Ch 9, Sec 5, [5.5.1]

We would like to confirm a way to apply the requirement of this sub-paragraph to a structural member shown in the attachment.

Figure : Variable cross-section stiffener

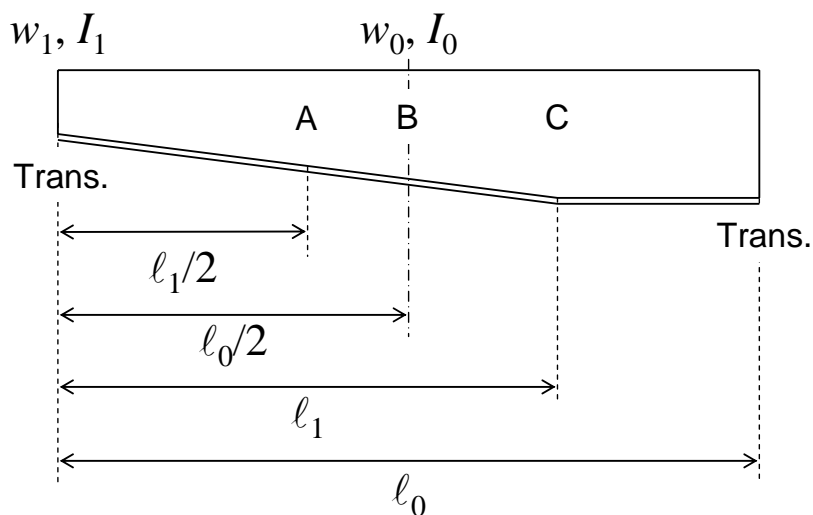
(1) Which position, A, B or C, shown in Figure, is to be selected to calculate w_0 and I_0 ?

We consider that position B is suitable for this requirement. Please confirm.

(2) Which position, A, B, C or else, is to be considered when the requirement of net section modulus of ordinary stiffeners, w , is applied?

We consider that position A is appropriate for this requirement. Please confirm.
